RE: Appolo Fuels, Inc.
Permit No. 807-0368, Original

In response to your third technical review letter dated September 8, 2009, we have made the following corrections to the above referenced application.

In response to your third technical review letter dated August 19, 2009, we have made the following corrections to the above referenced application.

In response to your second technical review letter dated July 23, 2009, we have made the following corrections to the above referenced application.

Appolo Fuels, Inc. Permit No. 807-0368 Backfilling and Grading Cross Sections (1 of 4)	
	Sections 1" = 100'	Attachment 25.1

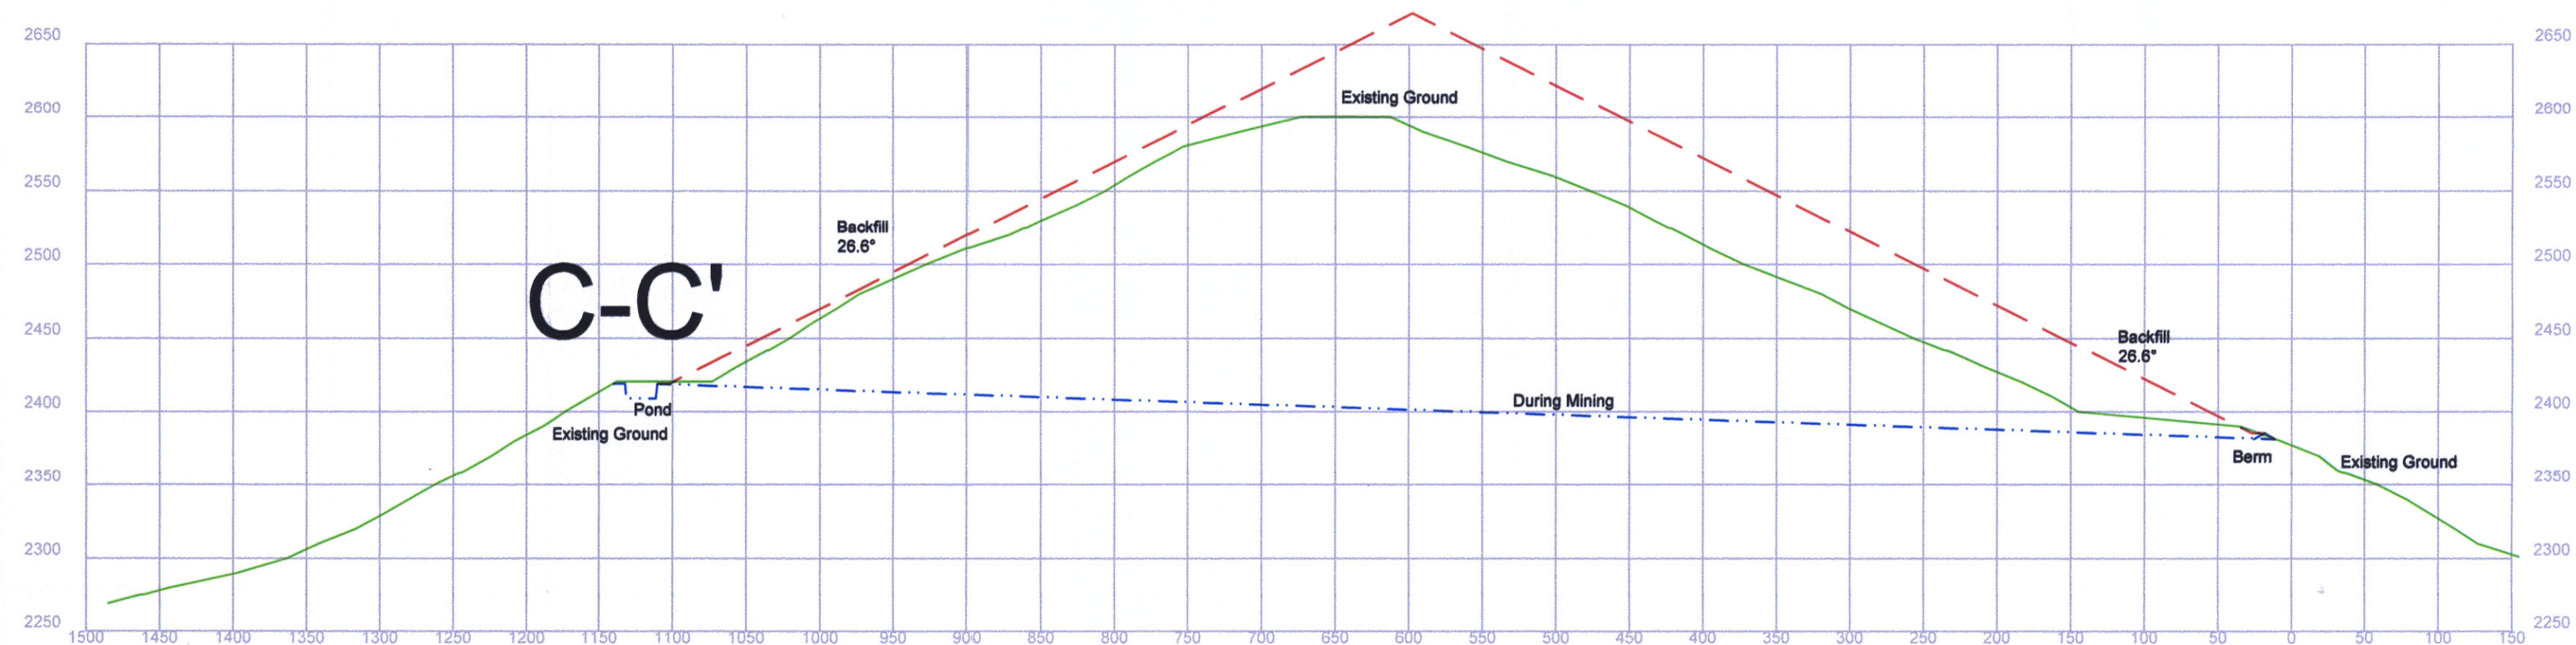
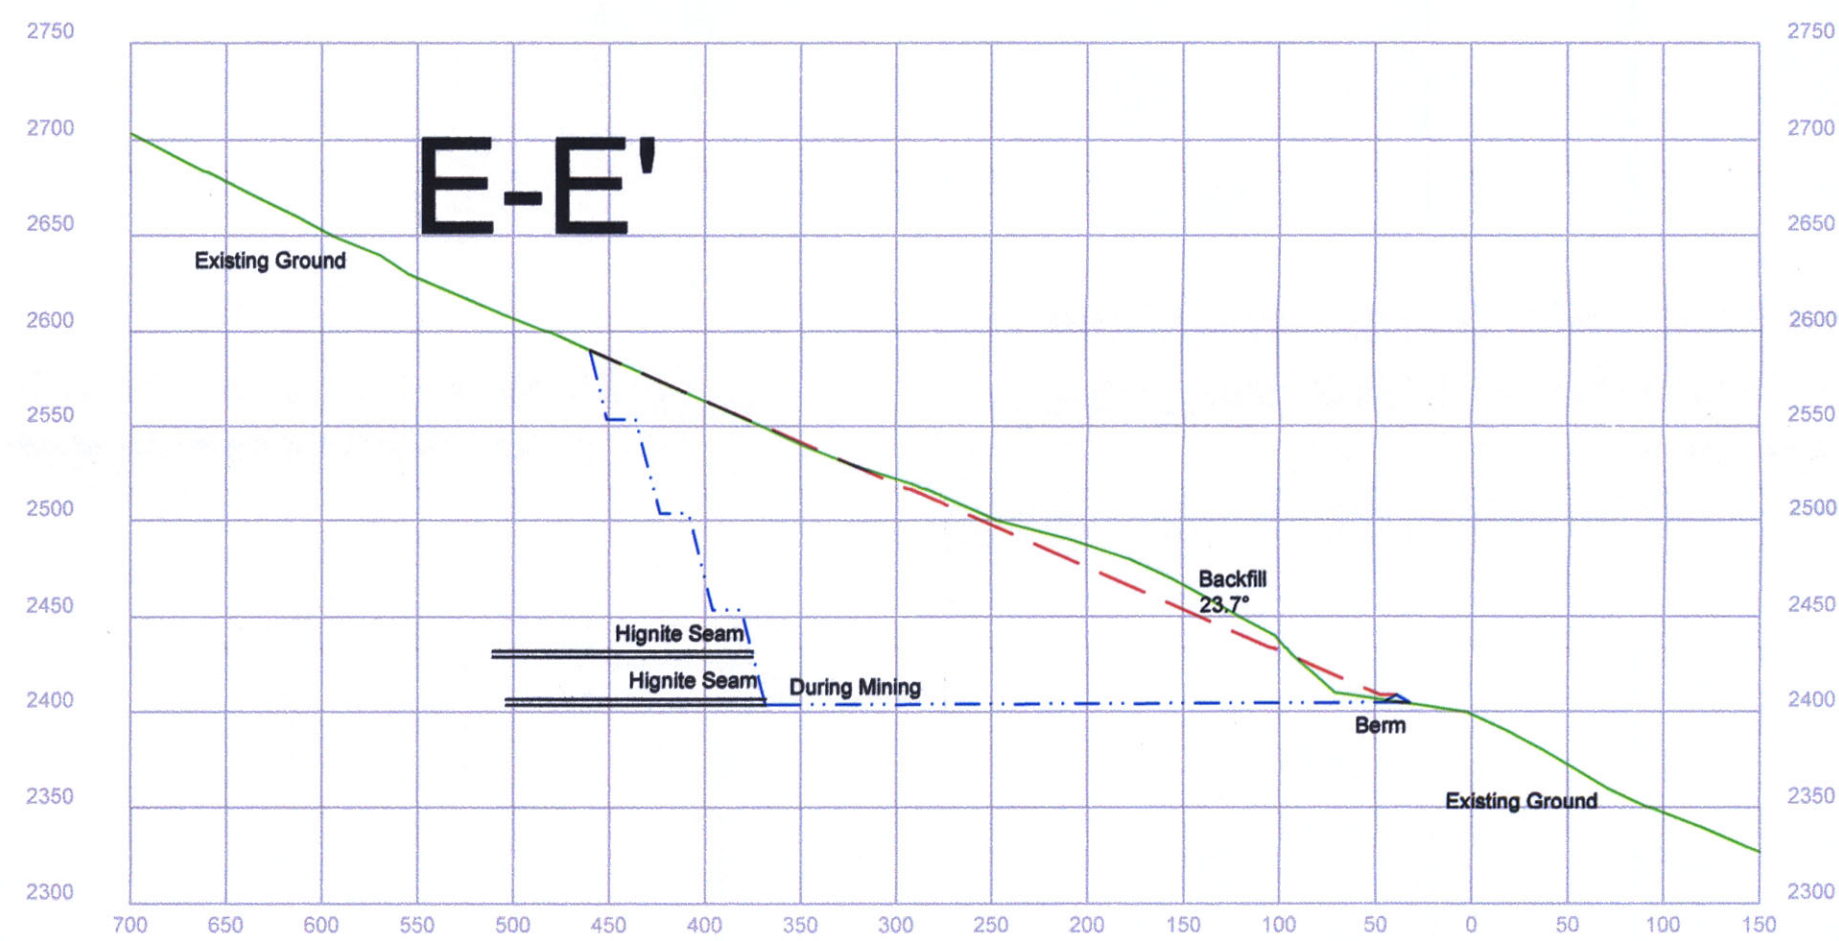
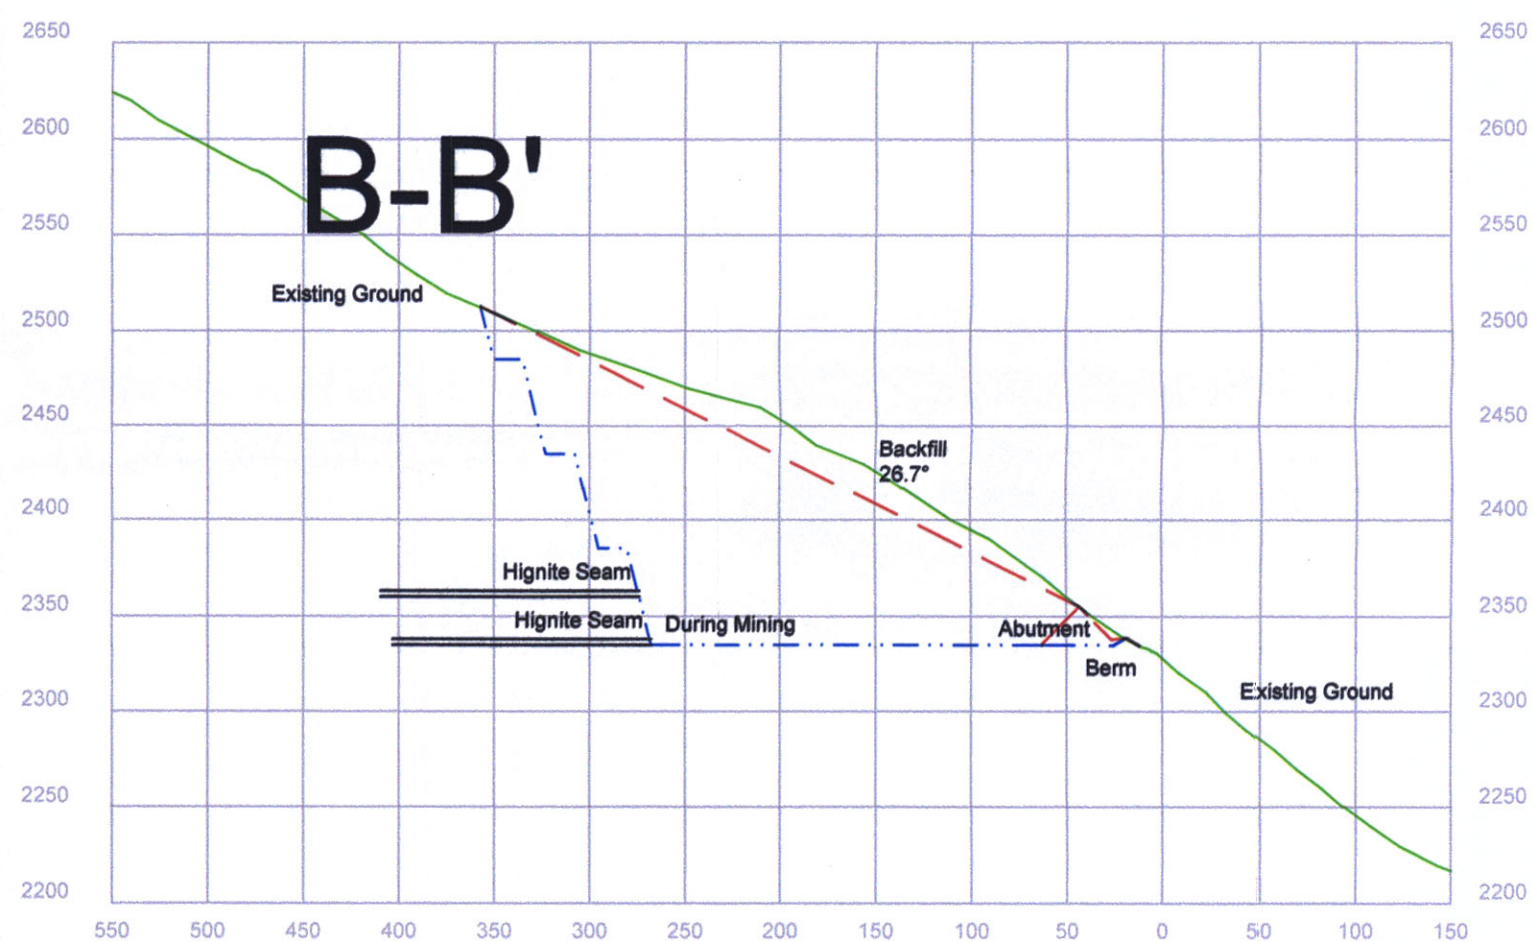
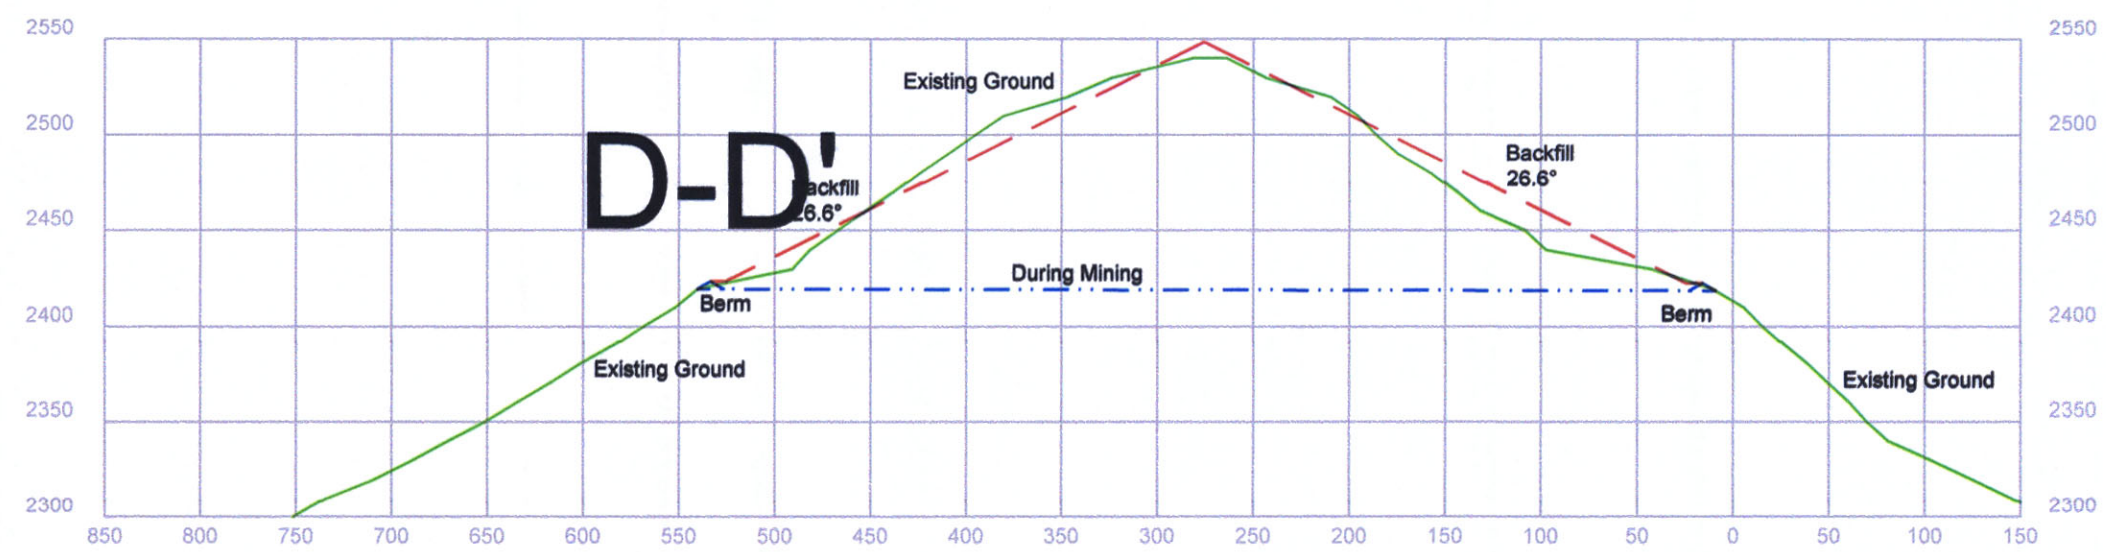
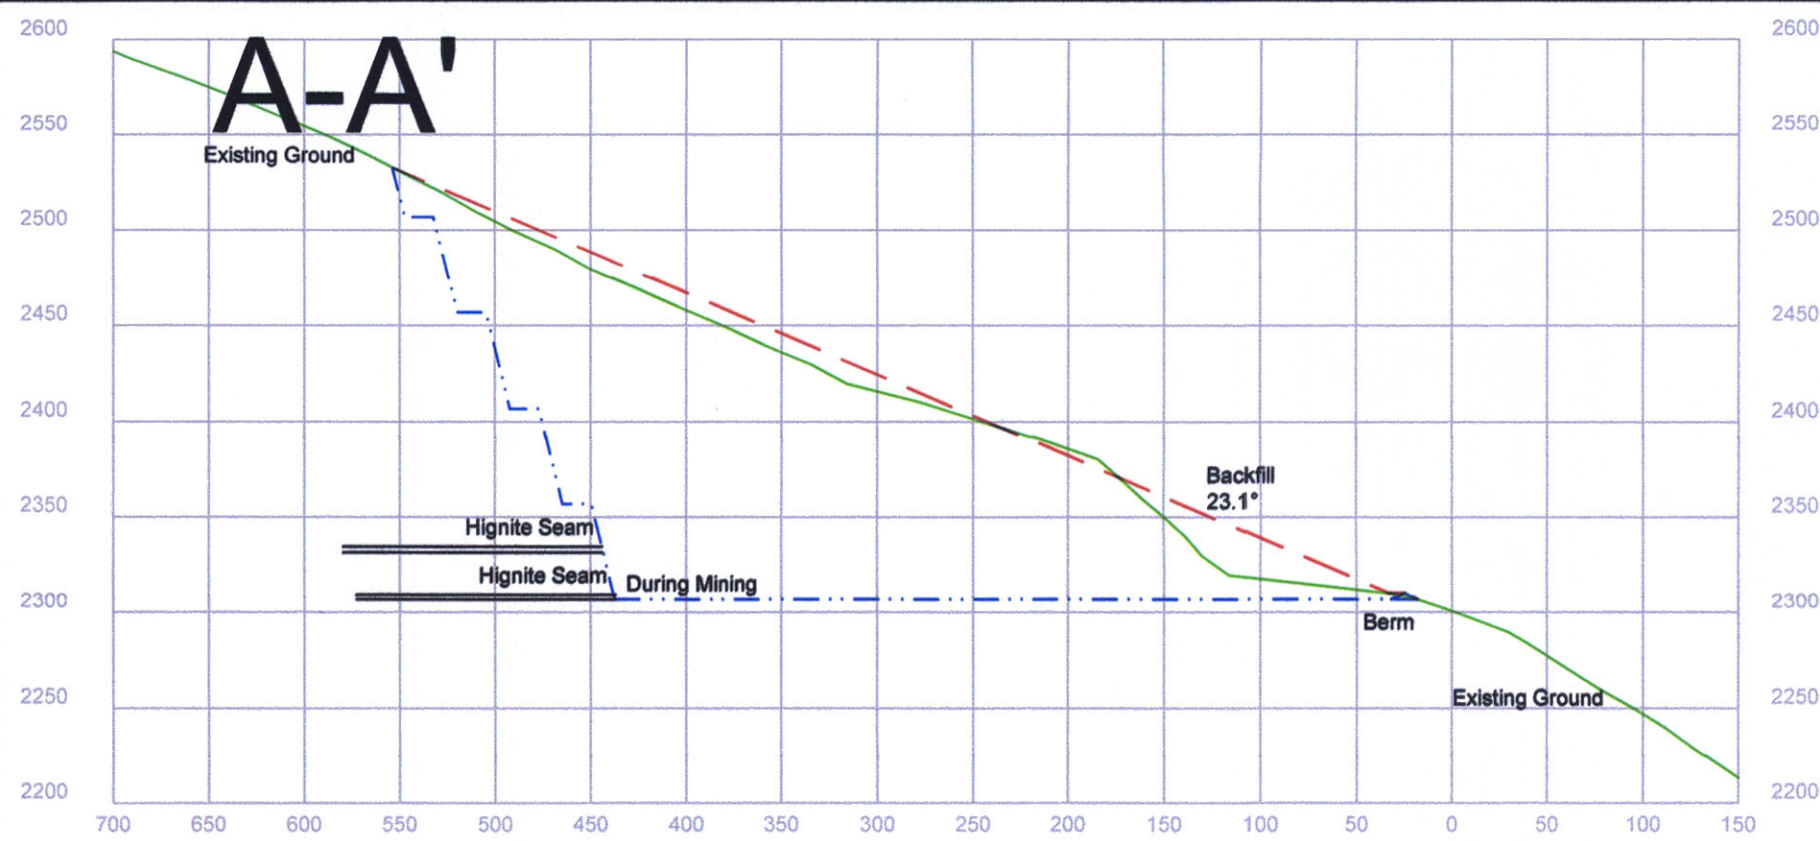
1. Attachment 25.1 [Backfilling and Grading Cross Sections; Sheet 1 of 4 (C-C')]: Please make sure that the existing ground (green line) is also shown.

- 1) Attachment 25.1: The green existing ground (green line) has been shown.
- 2) Attachment 25.4: Typical drawings for both types of seals have been provided. The strata lab analysis show that no acidic strata to be encountered during the mining operation and the seams to be mined do not have a history of acid mine drainage. Therefore, acid mine drainage (AMD) does not need to be addressed.
